**SUBJECT:** Calvert Cliffs Nuclear Power Plant  
Unit Nos. 1 & 2; Docket Nos. 50-317 & 50-318  
Request for Additional Information Regarding Measurement Uncertainty  
Recapture Power Uprate (TAC Nos. MC6210 and MC6211)

**NON-PROPRIETARY –**  
**REQUEST FOR ADDITIONAL INFORMATION REGARDING**  
**MEASUREMENT UNCERTAINTY RECAPTURE POWER UPRATE**

Figure 1: Loop 12 Piping Layout Upstream of the Mitsubishi Flow Straightener with the Main Feedwater Control Valve Simulated

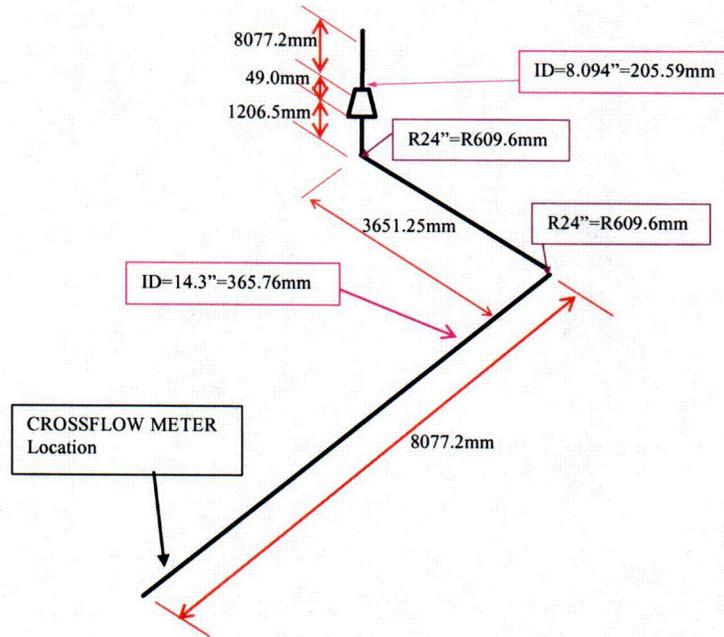
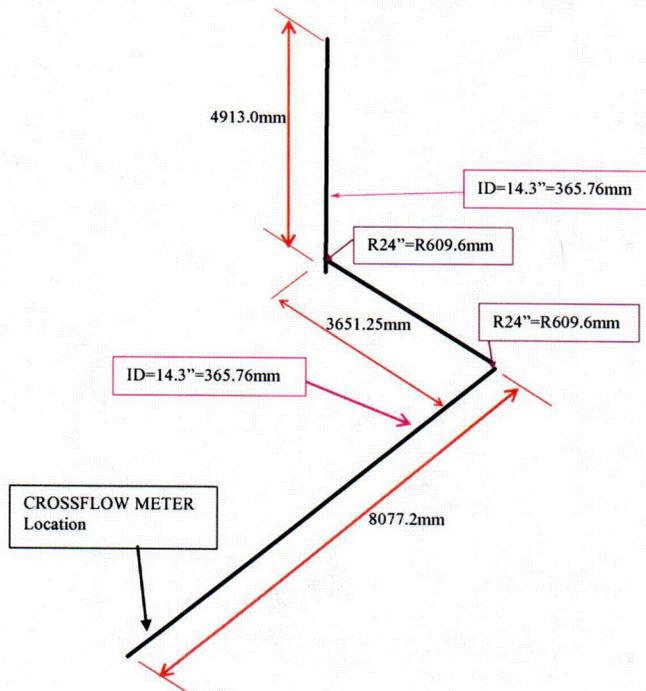
#### NRC RAI Question 1

*Provide a summary description of the followup tracer testing and the computational fluid dynamics (CFD) analyses that have been accomplished and the findings of each analysis and test. In the case of the followup testing, provide the unrecalibrated AMAG-indicated flow rates for each of the installed instruments (Crossflow and/or X-Beam), the flow rates determined using tracer testing, and flow rates from the venturis obtained during followup testing.*

Based on the tracer test results, it was decided to perform a Computational Fluid Dynamics (CFD) analysis of the piping upstream of the Mitsubishi flow straightener on Loop 12 in order to get a qualitative picture of what was happening to the flow field in the piping system. It was decided to model the piping up to the main feedwater control valve and to simulate the control valve by using an 8 inch pipe to represent the jetting action of the feedwater exiting the cage of the valve into the approximately 14 inch (inner diameter) feedwater pipe. For control purposes, a second model was also developed with the same piping configuration, but without the 8 inch control valve pipe simulation.

Figures 1 and 2 show the two CFD piping configurations with and without the 8 inch pipe. Figures 3 and 4 show the differences in swirl that are generated in the pipe due to the jetting action of the control valve and Figures 5 and 6 show the velocity profiles at the location in the feedwater pipe where the CROSSFLOW meter is located.
